REGENTS PARK
ESTATE -
MITIGATION SITE 1
ROBERT STREET

LANDSCAPE
REVIEW
STATEMENT

ACD
ENVIRONMENTAL

LOVELL
PARTNERSHIPS
LIMITED

scheme: Regent's Park Estates
 Mitigation Site 1 - Robert Street
 client: Lovell Partnerships Ltd
 drawing: Landscape Proposals
 date: September 2016
 scale: 1:100@A1
 drawing no: LOV20688-11
 drawn: JS checked: JC

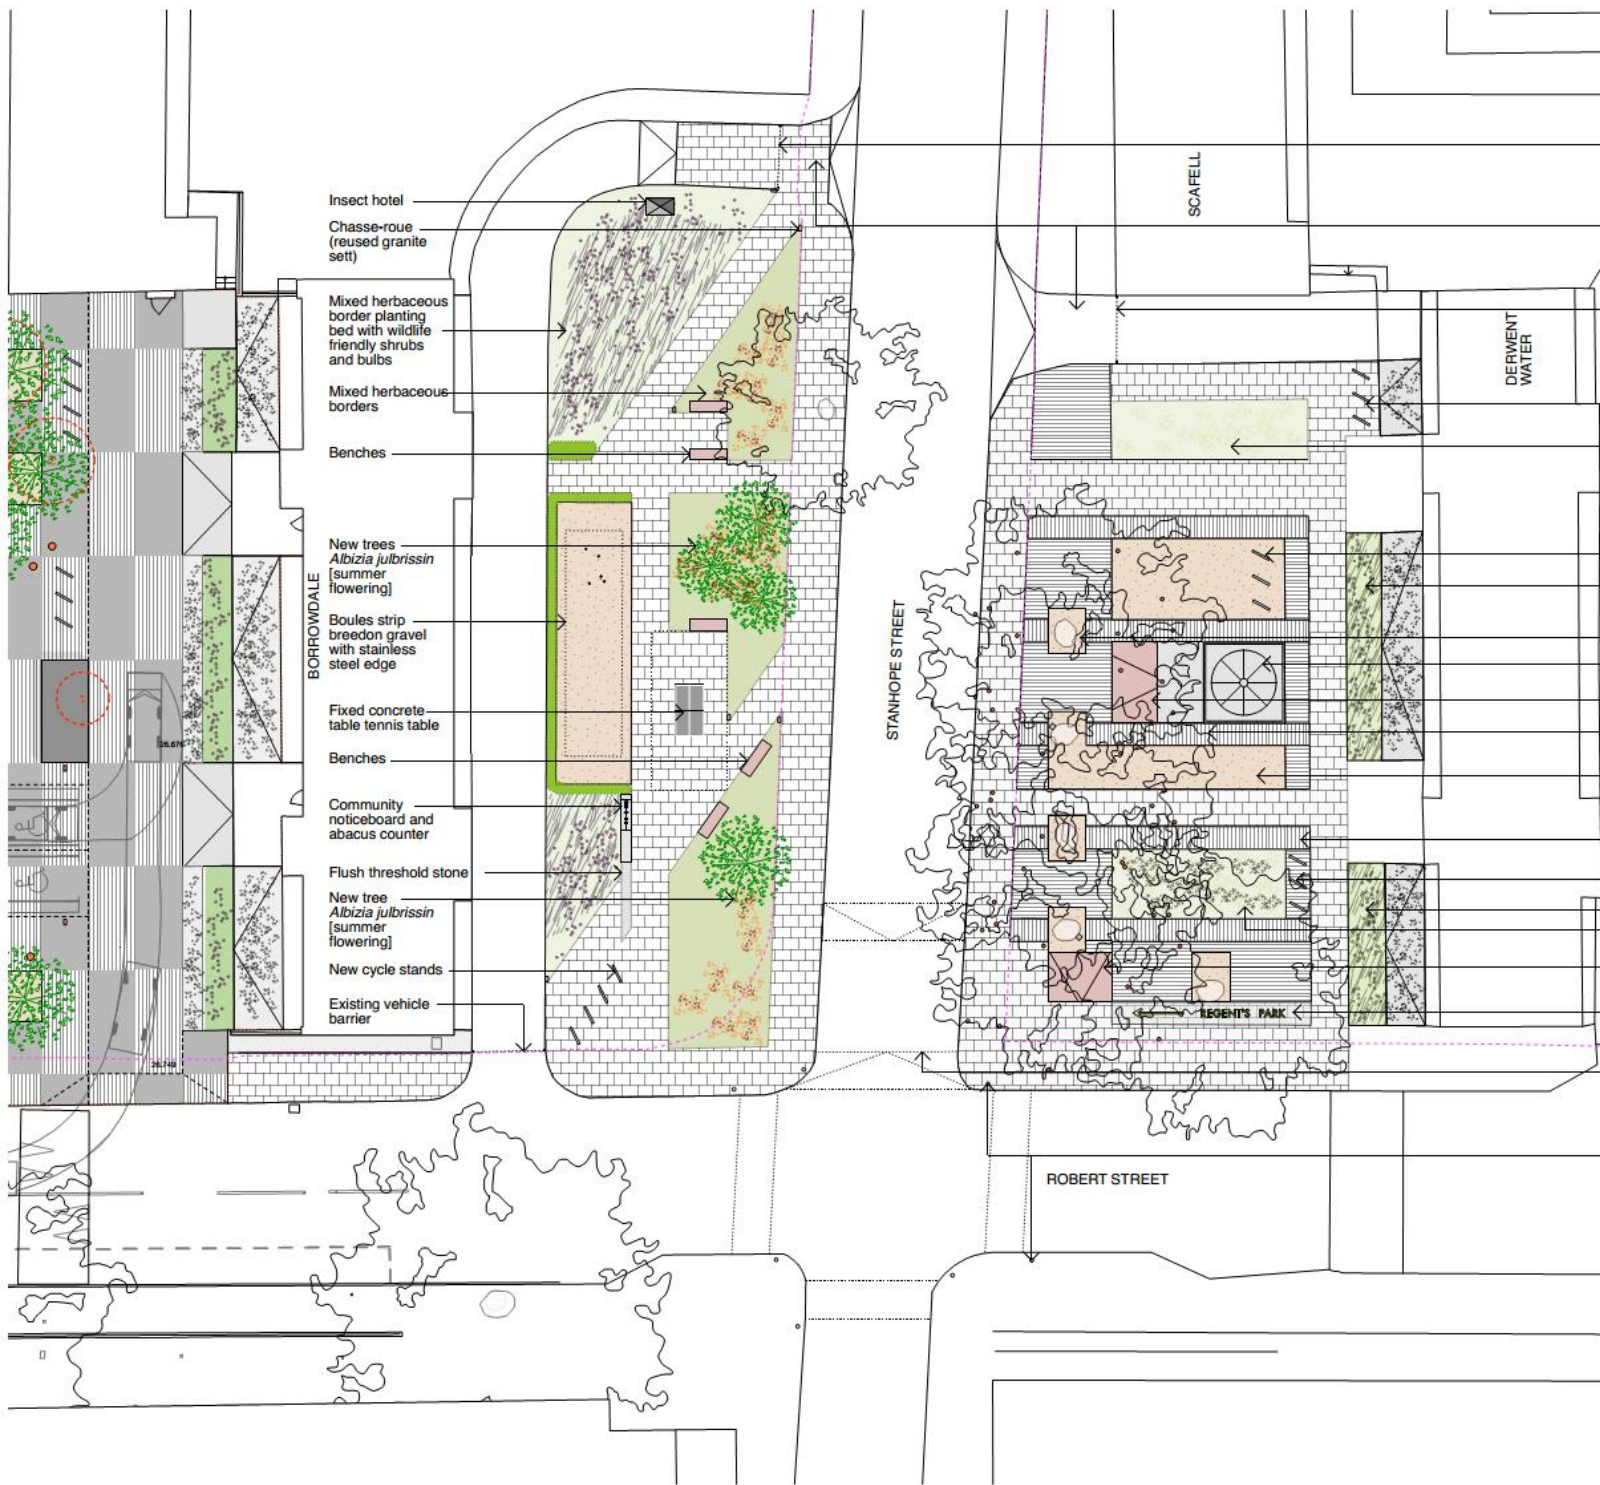
- 2.2. The proposed scheme does follow quite closely the approved East proposals with four specific changes. These changes include the restoration of the fountain, the removal of the lighting, amendments to some seating and the simplification of the grass, bulb and herbaceous planting.

- 2.3. The approved East proposals included the restoration of the foundation to a workable condition. The revised proposals include for the retention of this feature with works provided to create a feature of visual interest. This will be achieved by replacing the edging with new in-situ concrete edging, along with the removal of the removal of the cobbles. The former cobble areas will be filled with soil and low bamboo shrub planting, with a feature specimen within the central hole of the water feature.

- 2.4. Two raised large granite benches have been replaced with two conventional benches as have been used elsewhere within the site. The number and location of benches remain the same.

- 2.5. The areas of amenity grass, long grass, bulbs and herbaceous planting have been simplified to ensure a robust and manageable landscape. The quantum and location of planted areas remain the same, with areas specified as either amenity grass or wildflower grassland. The wildflower grassland includes for a diverse mix of long grass species, bulbs and herbaceous planting.

- 2.6. The extensive, random lighting pattern has been removed as this would create a maintenance issue with lighting installed within the existing tree root structures and within highway land.
